PICARD Bangladesh Ltd.

1143&1145, Konabari, Kashimpur Road, Gazipur
(23.910861N, 90.302220E)

3rd November 2015

Observations

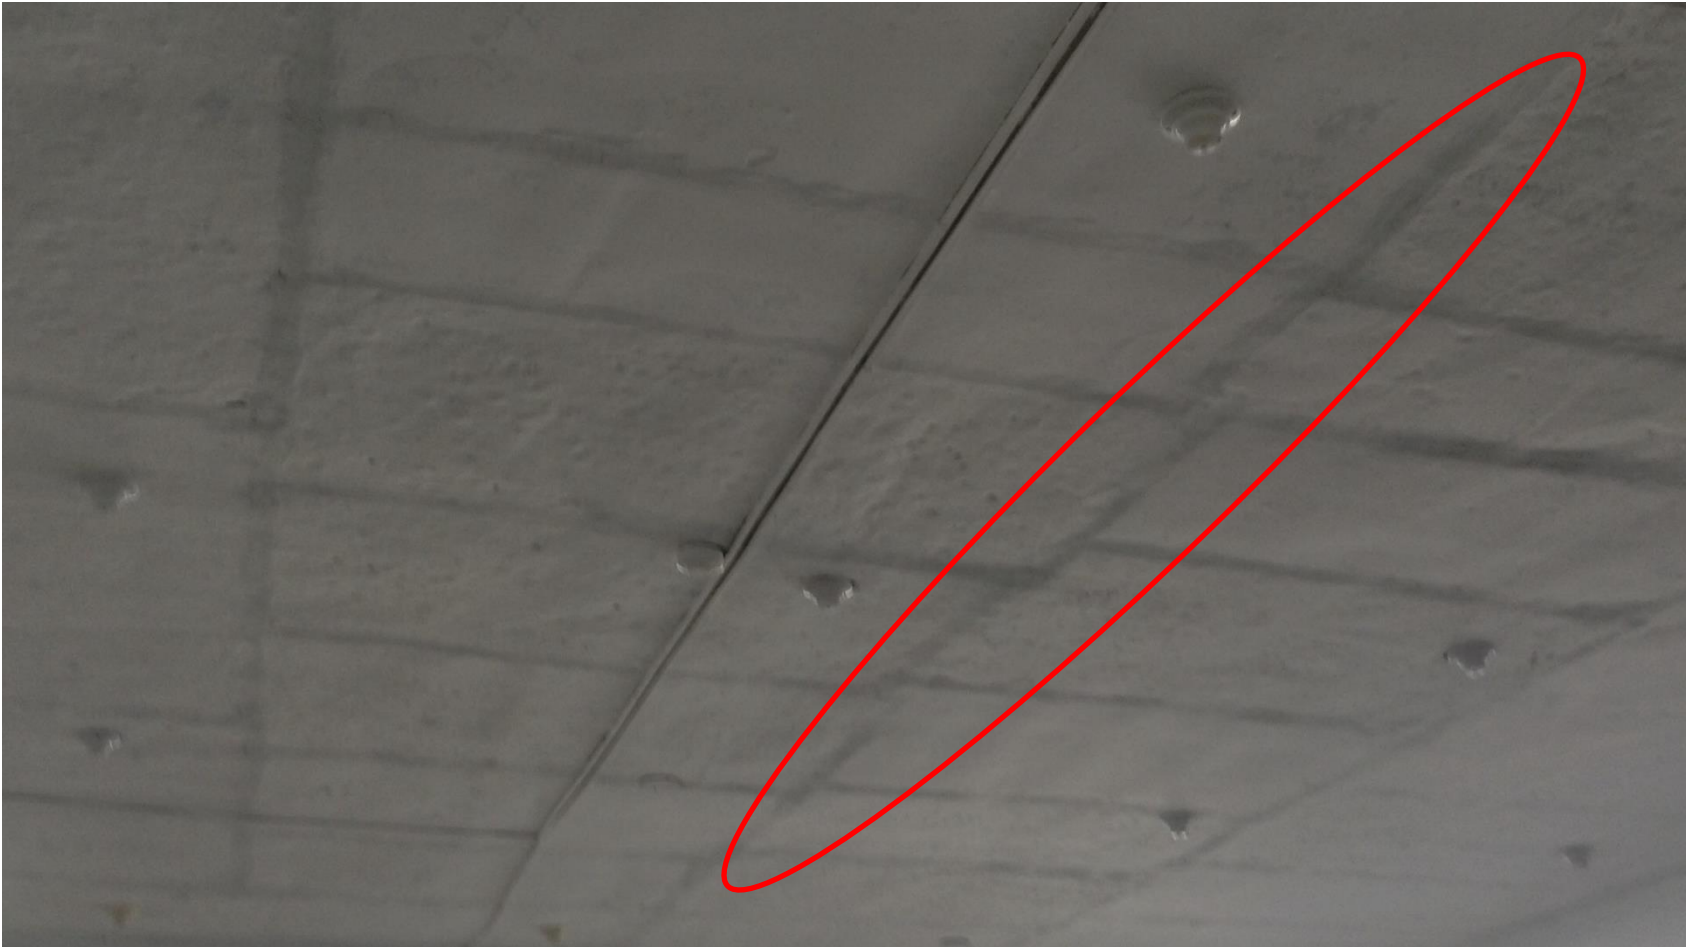
Discrepancies between site observations and information on drawings

Columns are not shown in Architectural Drawing for 7th Floor Presented in Structural Drawing and found in Present Condition.
